**140-148 DENISON STREET & 25-29 SMITH STREET, HILLSDALE
PROPOSED DEMOLITION, SUBDIVISION & BUNNINGS WAREHOUSE
DEVELOPMENT (DA 11/224)
RESPONSE TO RESOLUTION OF THE SYDNEY EAST JRPP**

**Re: Bunnings Warehouse East Gardens - Hillsdale
Loading Dock Noise Levels at Residences**

Figure 1 Part Section of Driveway Showing Roof and Barrier

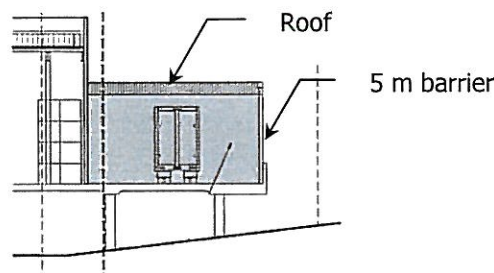
- Increasing the height of the barrier on the eastern and northern side of the site to a height of 5 metres.
- Installing a roof over the loading dock and part of the roadway.

The noise barrier and walls to the driveway and loading dock area will be of masonry construction and will provide adequate noise isolation between the development and residences. The roof to the dock area will be of metal sheeting construction with sarking and insulation to the underside of the roof.

In addition it is recommended that acoustic insulation be installed on the underside of the loading dock roof area to reduce reverberant noise buildup in the dock area. A suitable material is 25 mm polyester insulation with a density of 24 kg/m³.

Figure 2 Site Plan Showing Proposed Dock Treatment

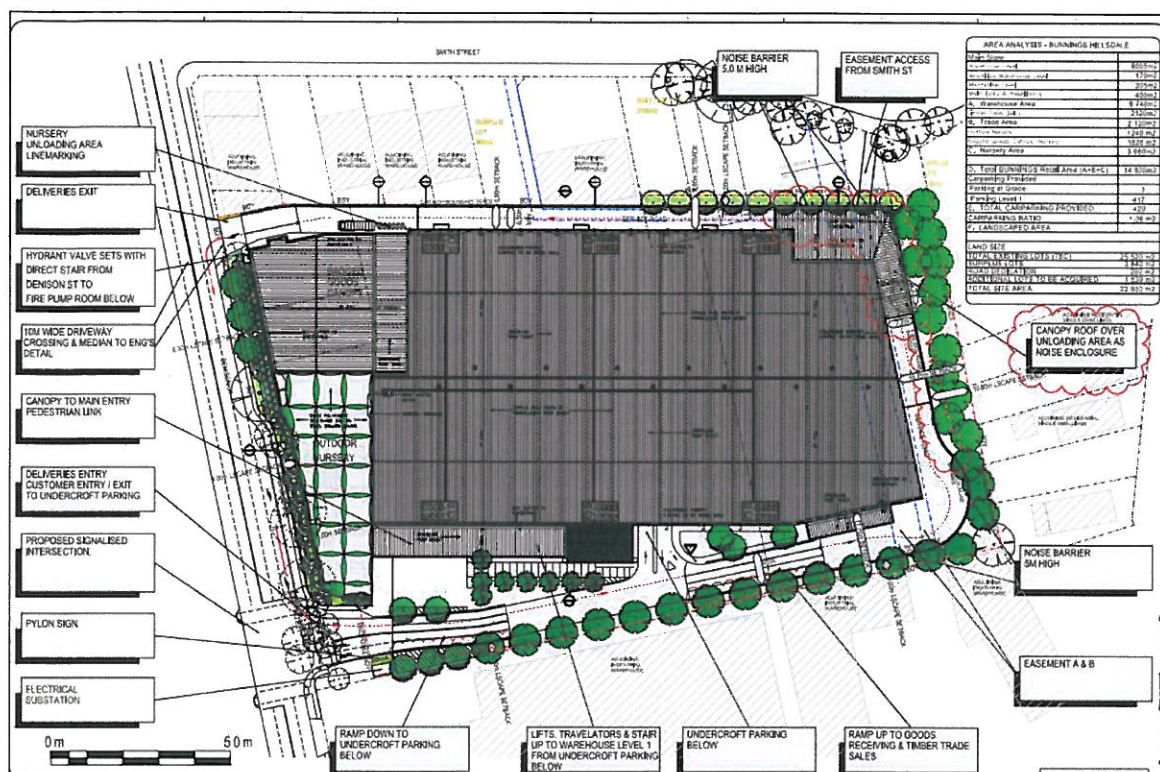
- Bunnings' preferred alternative includes an increase the height of the acoustic barrier from 3.5 metres to 5.0 metres along the entire eastern driveway edge as well as along the northern side of the GI, and adding a metal roof to enclose the GI area (inclusive of sound absorbing material to the underside of that roof).

Figure 4 $L_{Aeq}(15 \text{ minute})$ Bunnings Dock and Roadway noise contours - dBA

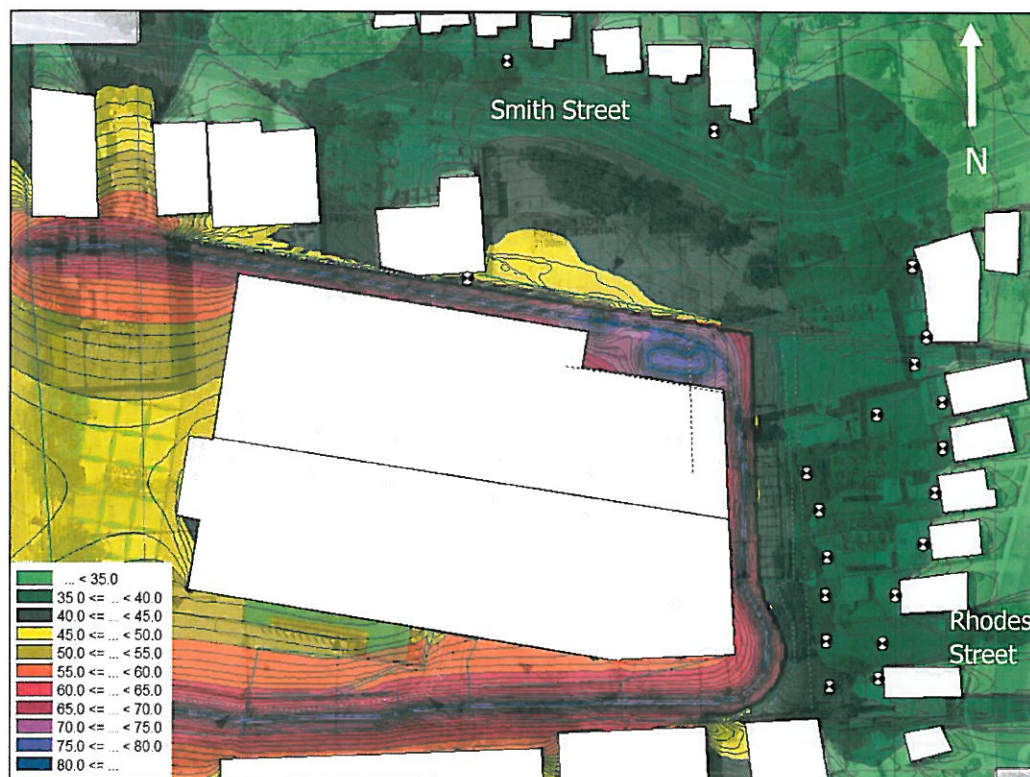
A review of the results indicates that resultant noise levels at residences associated with the loading dock and driveway activities (with the proposed treatments) will be at least 8 dBA below the most stringent noise criterion.

The highest noise associated with the loading dock and roadway operations are at 83 Rhodes Street where noise levels of up to 41 dBA are predicted at the upper level of this residence. At other surrounding residences noise levels in the order 38-39 dBA are predicted. These levels compare with measured background noise levels of 46 and 44 dBA, for the day and evening period respectively.
